CITY OF SANTA FE

# Planning and Land Use Department Planning Commission Staff Report

| <b>Cases Nos:</b>     | 2024-8550 and 9304   |
| <b>Proposal:</b>      | Applicant requests development plan approval to construct approximately 46,435 square feet of new construction for Fiesta Nissan and Fiesta Hyundai Automotive Dealerships on +/-11.9 acres. |

**Figure 5 Fire Hydrants**

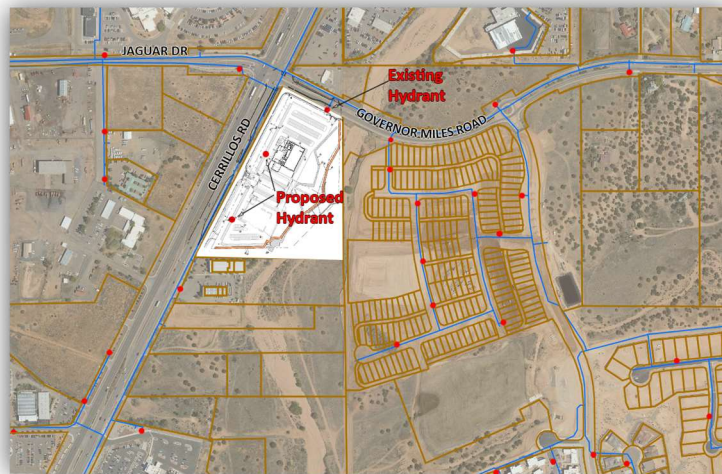
There is one existing fire hydrant next to the project. The existing hydrant is located northwest of the Governor Miles driveway. The Applicant is proposing two new fire hydrants: one per lot, and west of each building. See Figure 8 *"Fire Hydrants."* The Fire Marshal's review did not find if the building was sprinkled or not or where Fire Department Connections are for the buildings. Conditions of approval have been included in Section III *"Conditions of Approval"* of this report.
